Amalfi

12337 30th Ave. NE

REC Meeting #2 | SDCI #303584-LU

06/28/2021

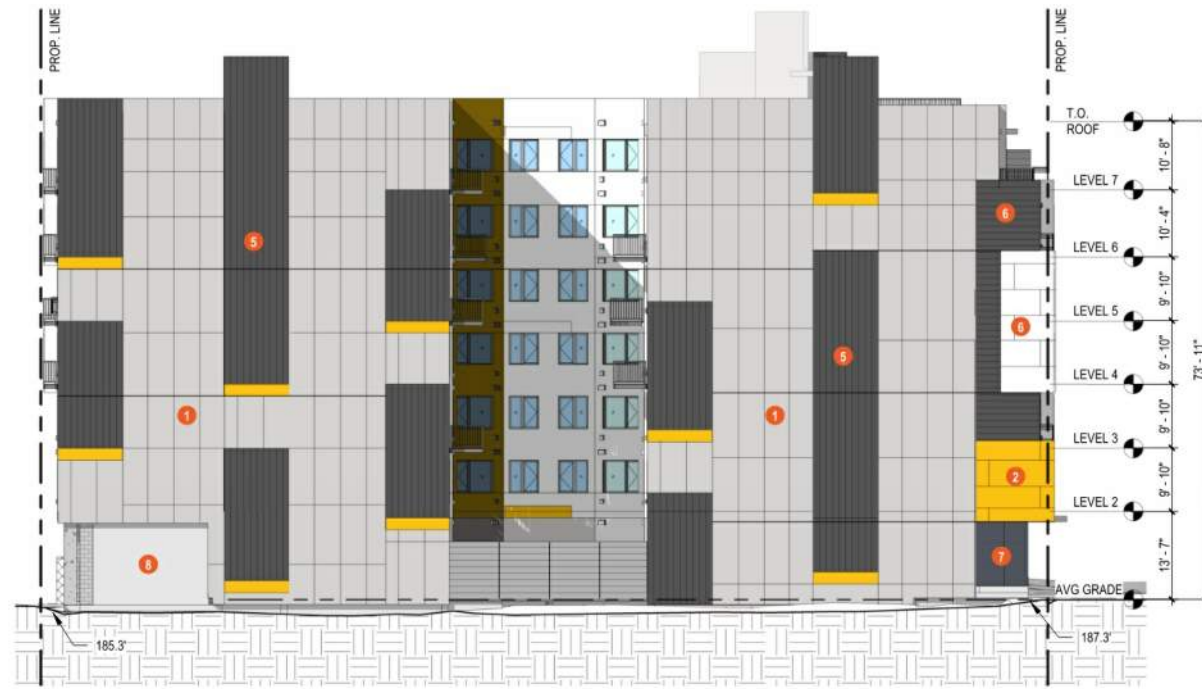
b. *...The Board suggested the applicant improve the lighting in the alley..The Board went further with the bike entry and recommended additional lighting.*

Response: Lighting has been added to the alley and between the bike entry and the sidewalk

① Previous Design - View at 30th

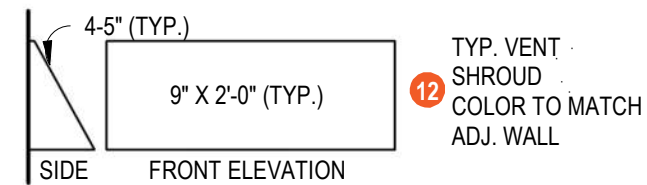
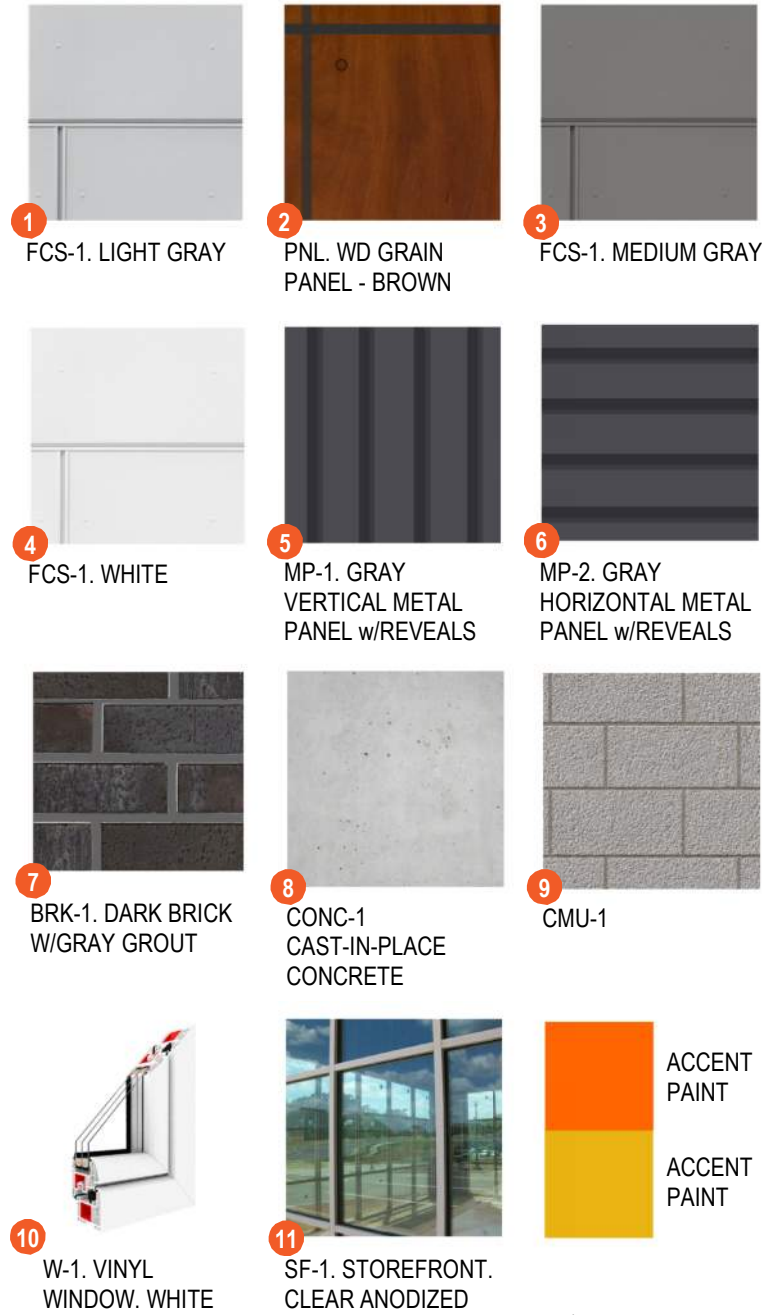
Comment:...The Board noted the application of color, especially with the bays, needed further study and better color integration...Board recommended the applicant simplify the accent colors and study which accent colors may work best on each façade. The Board also recommended the applicant identify one expression on each façade and maintain that expression instead of combining multiple expressions.

Comment:...The Board recommended the applicant incorporate civic art...on the south façade.

Response: The use of an accent color has been significantly reduced. A wood/wood-like material that is more subtle than the accent color and residential in feel has been added. With the addition of the art to the south façade, we felt that a muted, simplified south façade would allow more flexibility with the art and not compete with it for attention. The resulting design of the south facade uses modules related to the east facade doesn't reference the cascade expression.

The southern, double bay return has been expanded along the south face to create a space for the art.

① VIEW SOUTH FROM 30TH

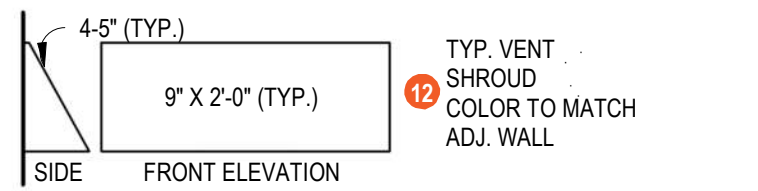
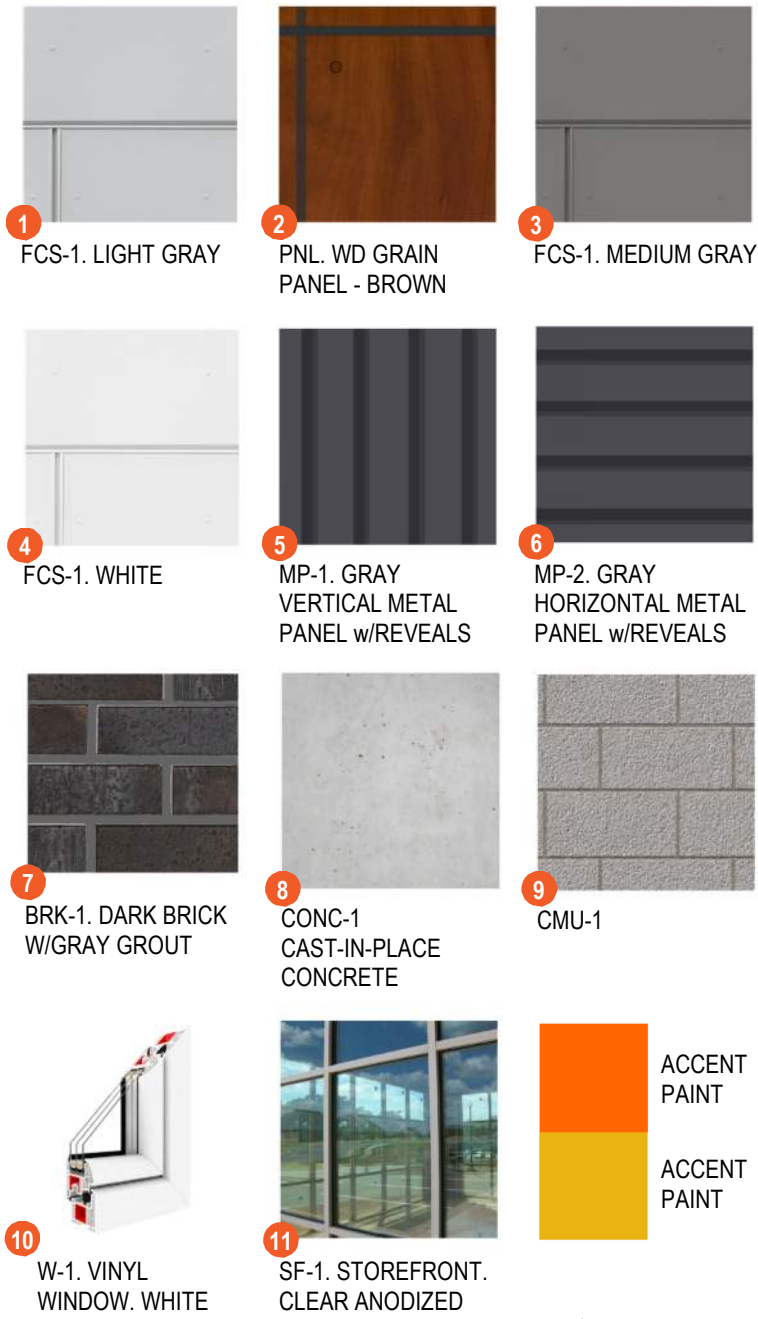
Comment: *The Board noted the architectural language on the north façade should be clarified by simplifying the façade...*

Response: The north facade has been simplified and muted to be consistent with the south facade. Panels affixed to the balconies have been changed to the wood/wood-like material to add consistency with the east facade.

Lighting Plan - Level 1
1" = 30'-0"

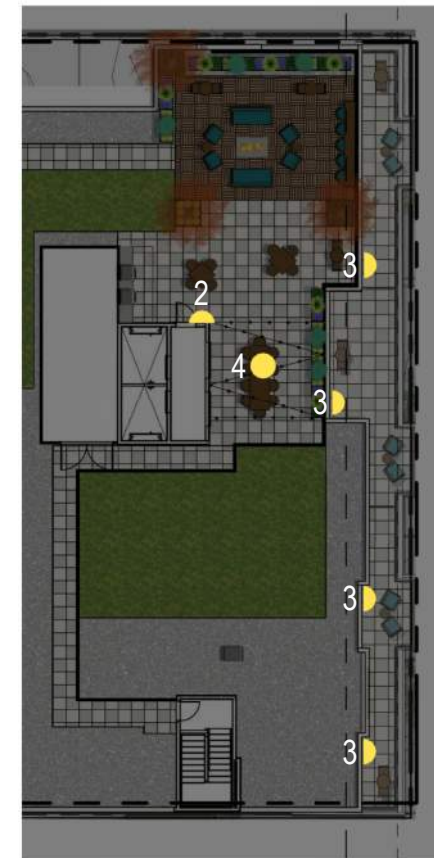
Comment:...The Board recommended the applicant explore ways to further highlight the bike entry from the street...

Comment:...The Board suggested the applicant improve the lighting in the alley..The Board went further with the bike entry and recommended additional lighting.

Comment:...The Board suggested the applicant improve the lighting in the alley..The Board went further with the bike entry and recommended additional lighting.

Response: Graphics will be added to the north wall of the project that connect the bike entrance to the sidewalk.

Response: Lighting has been added to the alley and between the bike entry and the sidewalk

Response: Lighting has been added to the alley and between the bike entry and the sidewalk

WEST ELEVATION - ALLEY
1/16" = 1'-0"

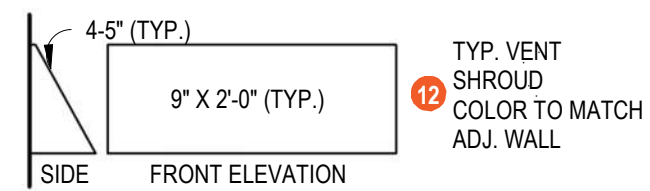
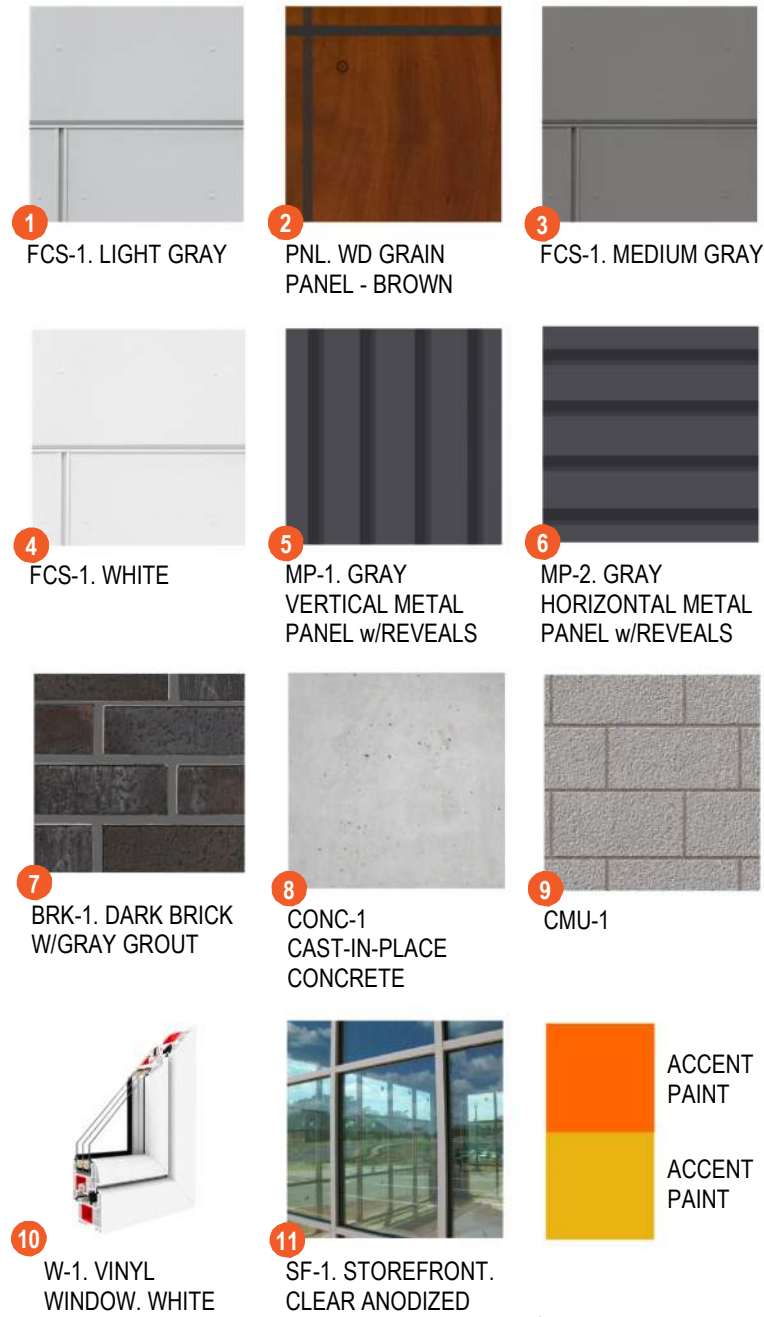
d. The Board commented that the bay window concept does not carry through on the west façade. The Board questioned how the cascading concept comes into play...The Board thought the west façade had two competing design logics currently expressed...

Response: The design of the west façade has been completely revised. The scheme is much more simplified and uses one expression rather than a mixing of two.
